State of Washington Department of Ecology
Northwest Regional Office
**STORMWATER COMPLIANCE INSPECTION
REPORT**

Inspection Date 7/26/06	NPDES Permit # WAG 503008	County Snohomish	Receiving Waters Stilliguamish River S Fork
----------------------------	-------------------------------------	---------------------	--

Name and Location of Facility Inspected Iron Mountain Quarry Granite Falls 21100 Wayside Mine Road Granite Falls, WA 98252	Entry Time 1145	Permit Effective Date 2/14/2005
	Exit Time 1300	Permit Expiration Date 2/14/2010

Photo #: 1

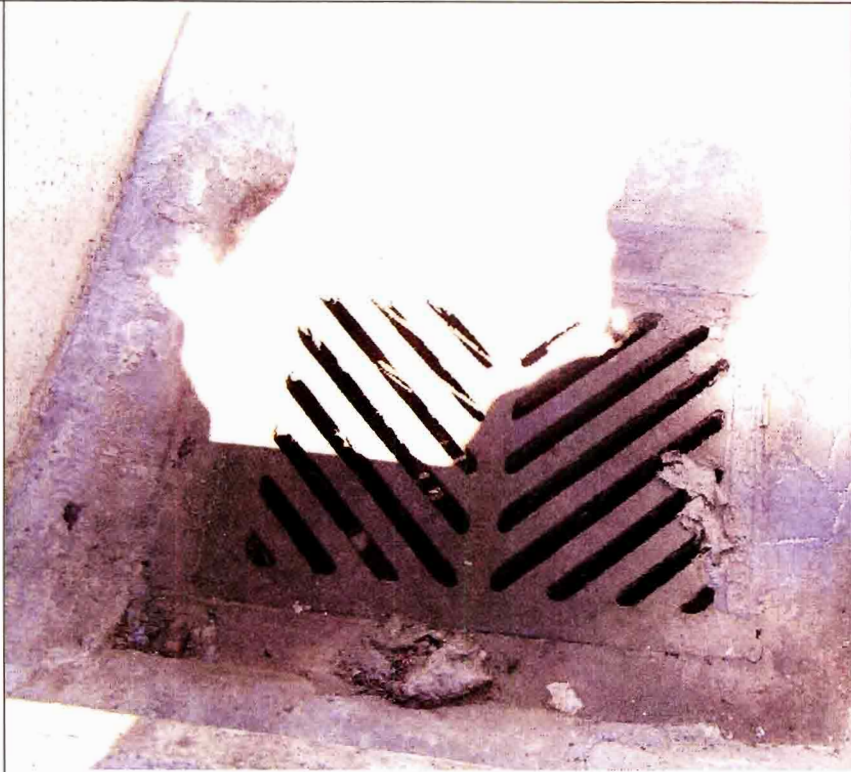
Pictured here is the secondary containment area where the large fueling tanks are placed. This drain within the containment area appears to be connected to the storm pond. The drain needs to be plugged immediately. The stormwater in the containment is considered contaminated and may not be discharged. This water must be taken off the property and disposed of by a qualified disposal company. No discharge of pollutants to ground or surface water is allowed.
